ORIGINATION FORM

Proposed Revisions to a Standard Plans Index
(Please provide all information — Incomplete forms will be returned)

Index Number: 102-660
Sheet Number (s): 1
Index Title: Pedestrian Control for Closure of Sidewalks

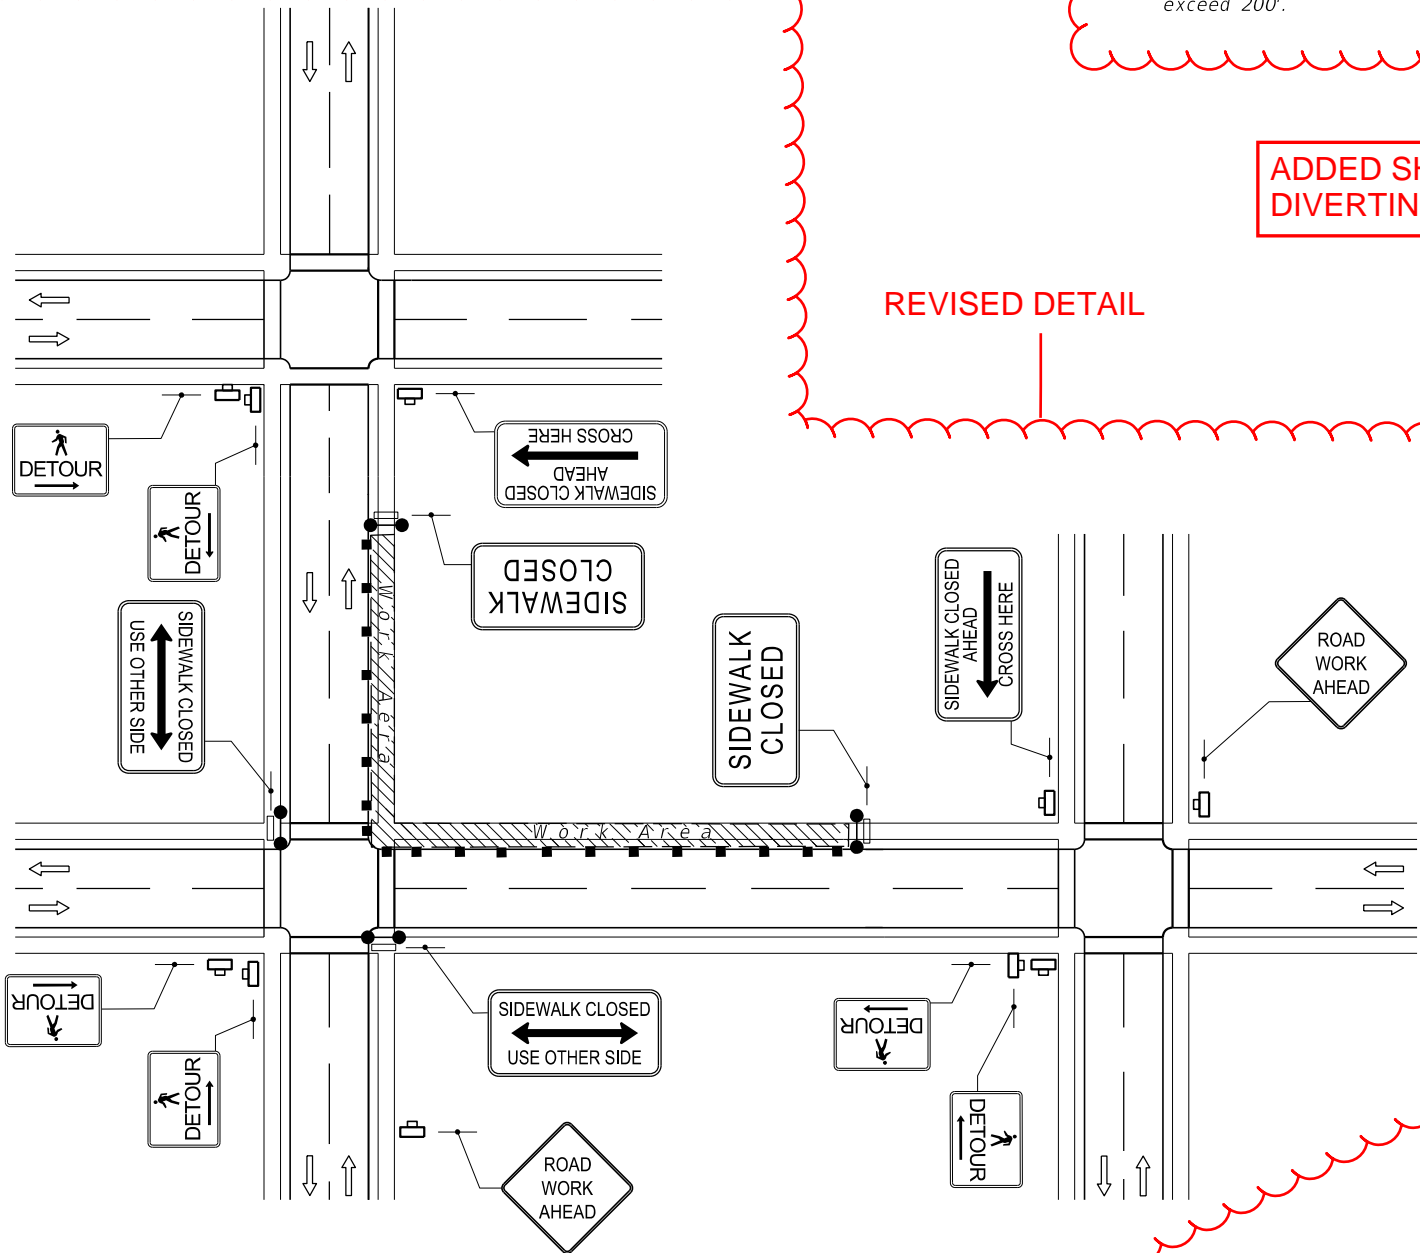
UPDATED SYMBOLS

REVISED NOTES

~~CROSSWALK CLOSURE AND PEDESTRIAN DETOUR~~

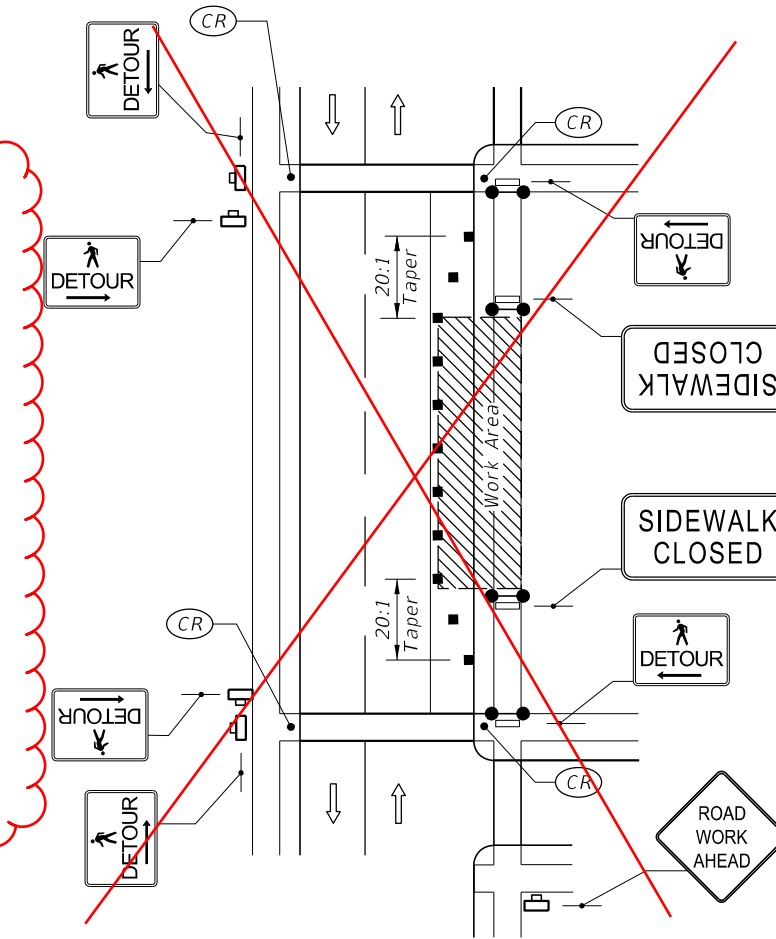
REVISED DETAIL

~~SIDEWALK DETOUR~~

~~SIDEWALK DIVERSION~~

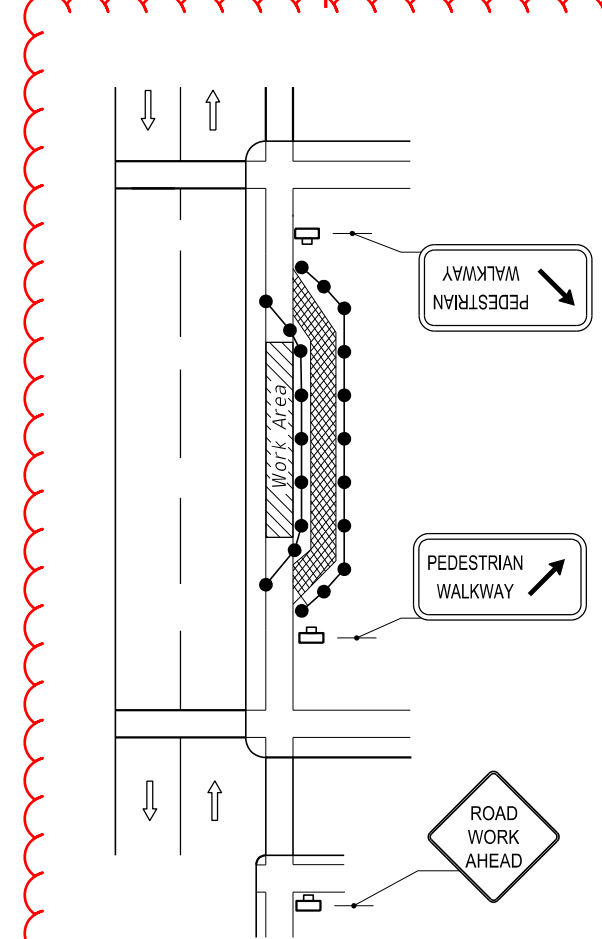
REVISED DETAIL AND MOVED TO SHEET 2

LAST REVISION 11/01/20	REVISION	DESCRIPTION:	 FY 2021-22 STANDARD PLANS	SIDEWALK CLOSURE	INDEX 102-660	SHEET 1 of 2
---------------------------	----------	--------------	--	------------------	------------------	-----------------

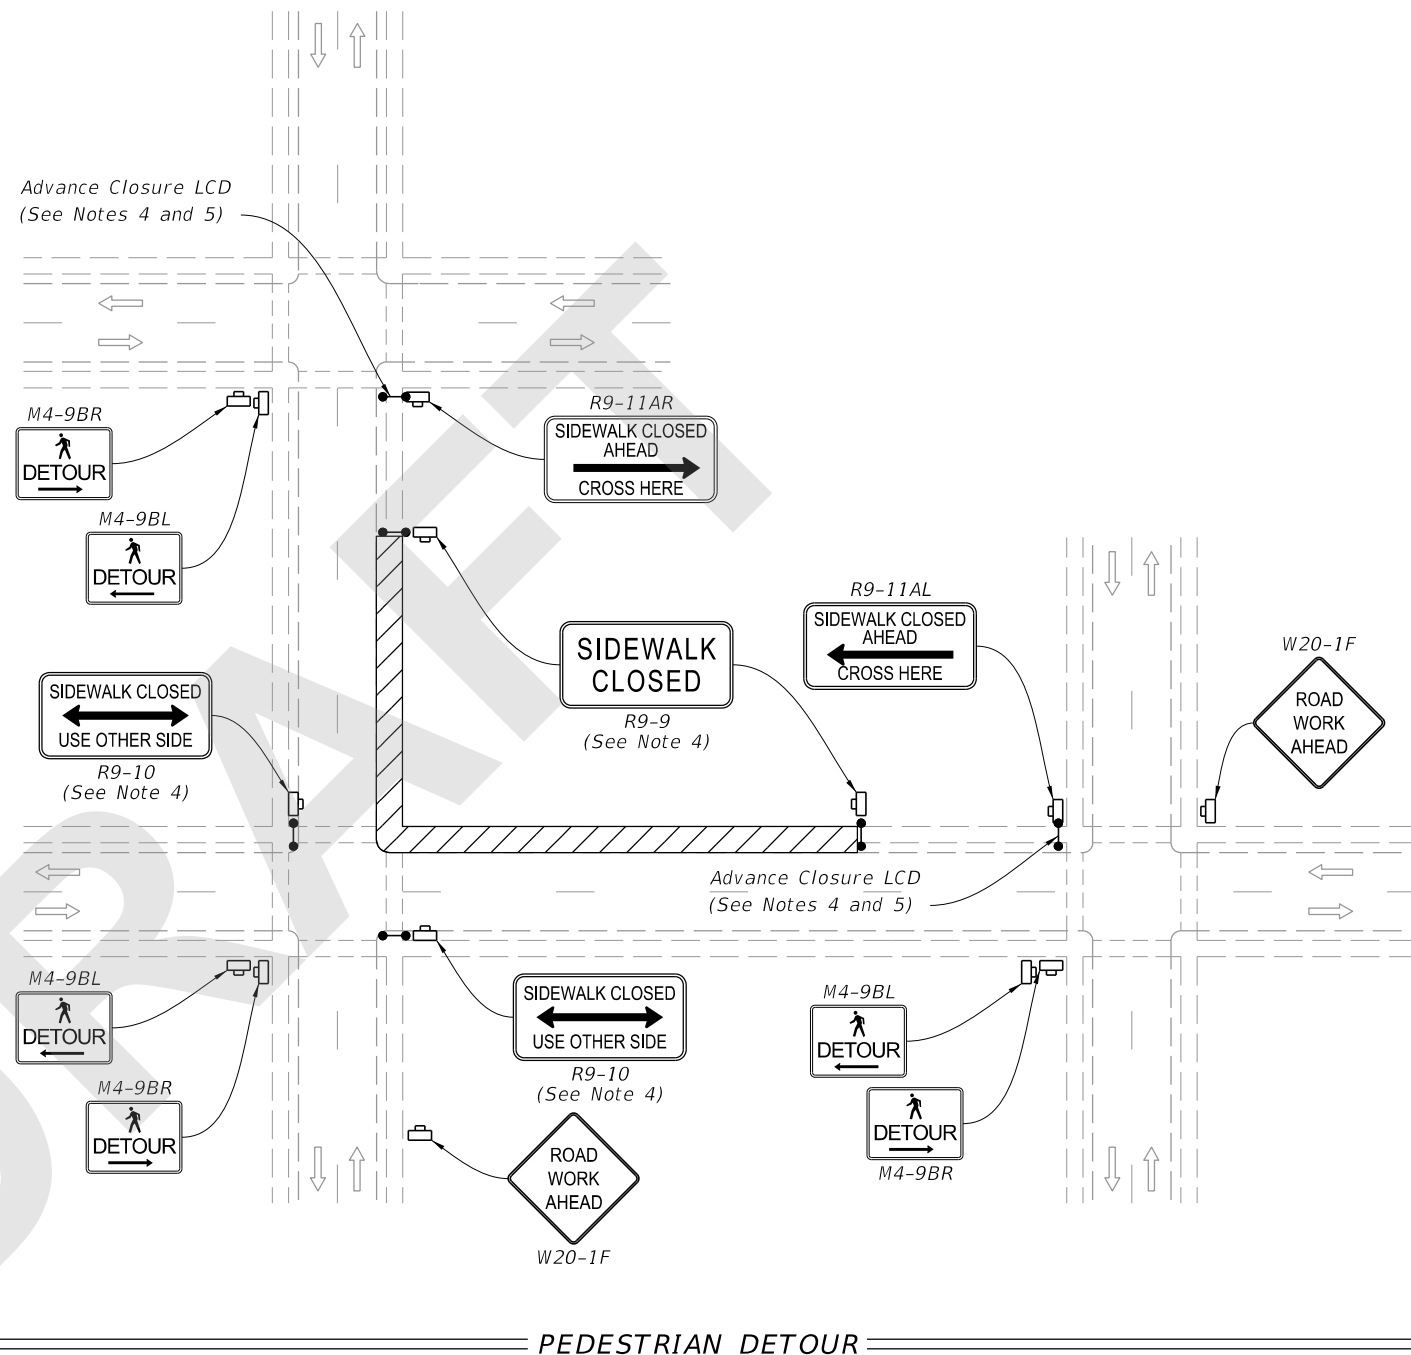
Sheet 1: Updated Symbols; Revised 'Pedstrian Detour' Detail; Revised Notes; Moved 'Sidewalk Diversion' Detatil to Sheet 2; Deleted 'Sidewalk Detour' Detail; Renamed Index.

LAST REVISION 11/01/20	REVISION	DESCRIPTION:		FY 2021-22 STANDARD PLANS	SIDEWALK CLOSURE	INDEX 102-660	SHEET 2 of 2
---------------------------	----------	--------------	--	------------------------------	------------------	------------------	-----------------

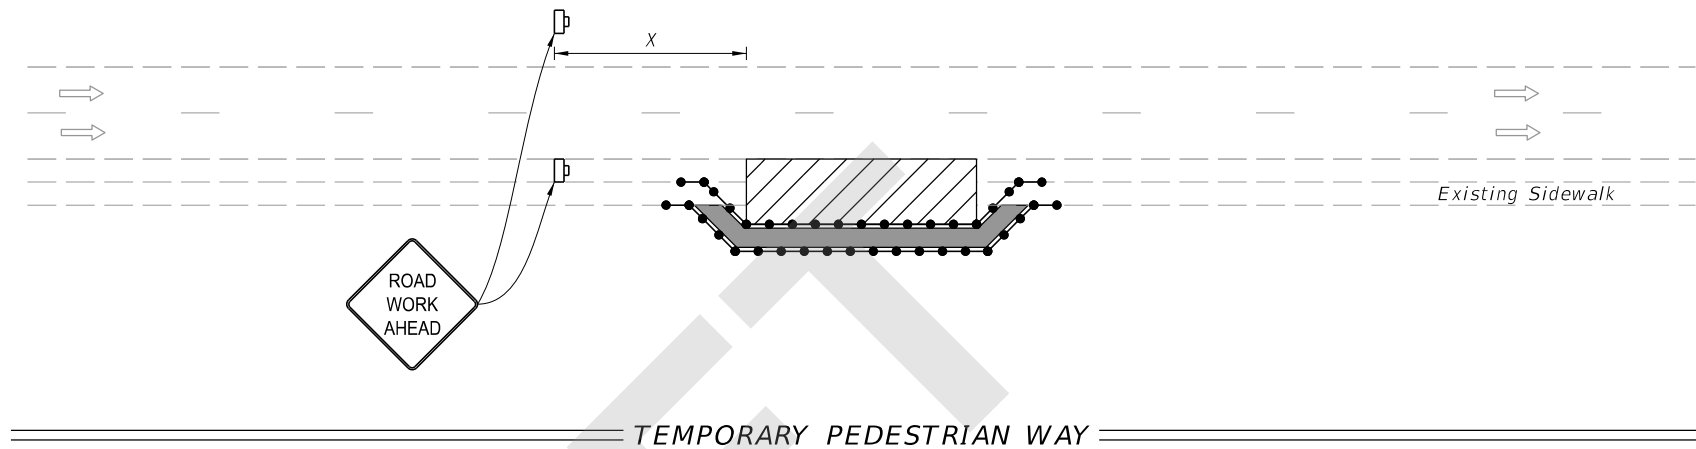
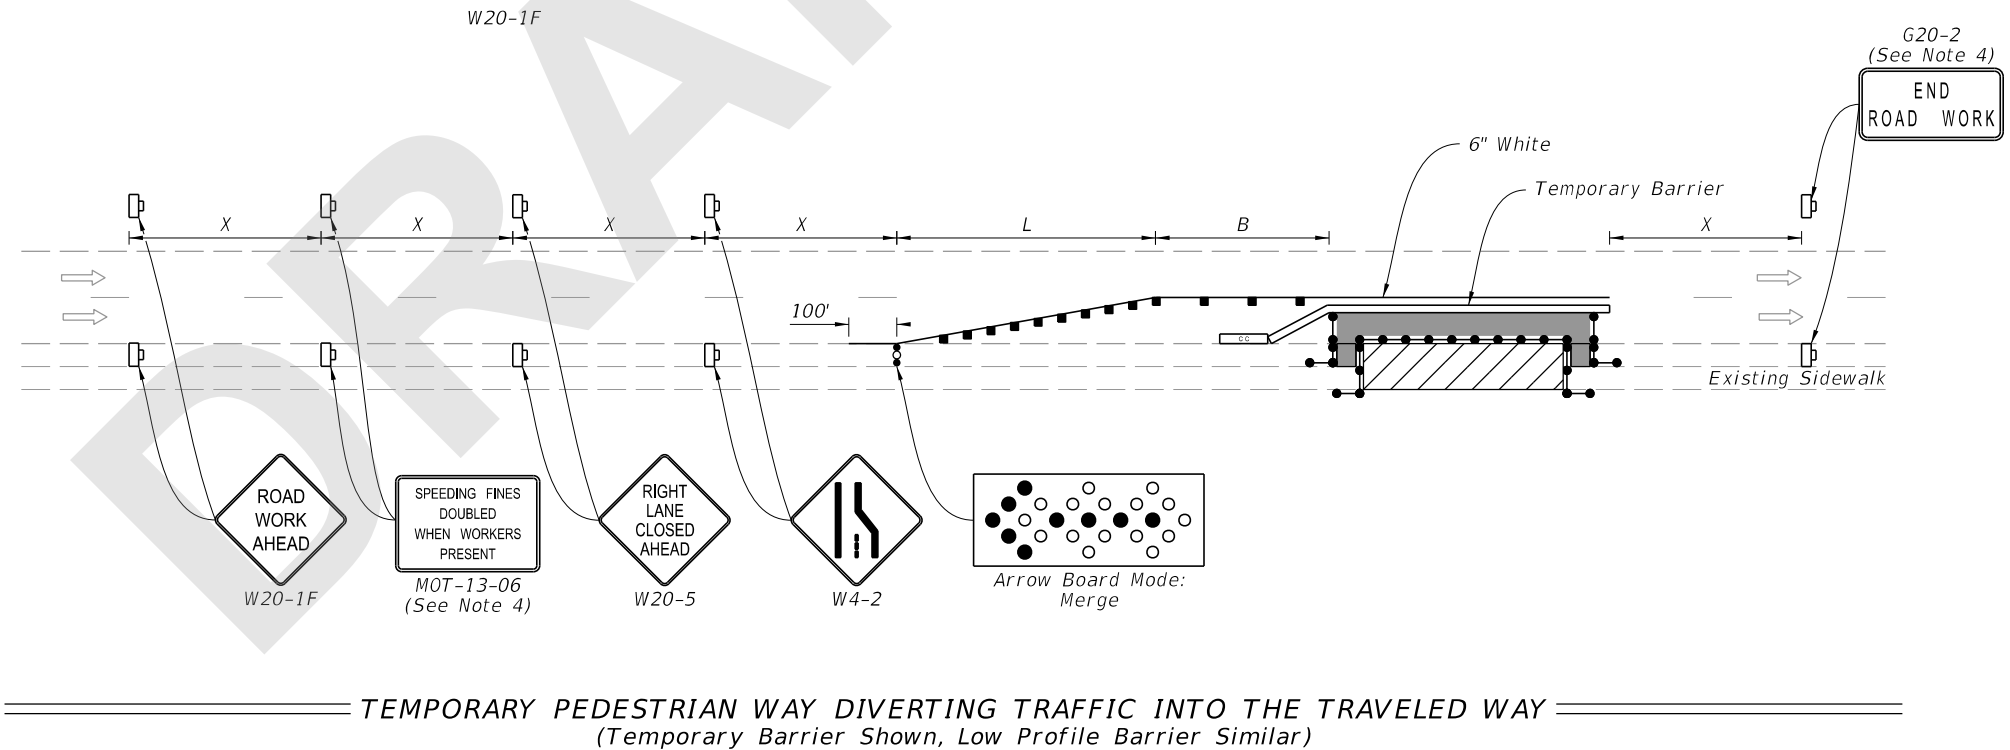
Sheet 2: Added Sheet 2; Added 'Temporary Pedestrian Way Diverting Traffic Into Traveled Way' Detail; Added and Revised 'Sidewalk Diversion' Detail from Sheet 1.

ADDED SHEET 2 AND "TEMPORARY PEDESTRIAN WAY DIVERTING TRAFFIC INTO TRAVELED WAY" DETAIL
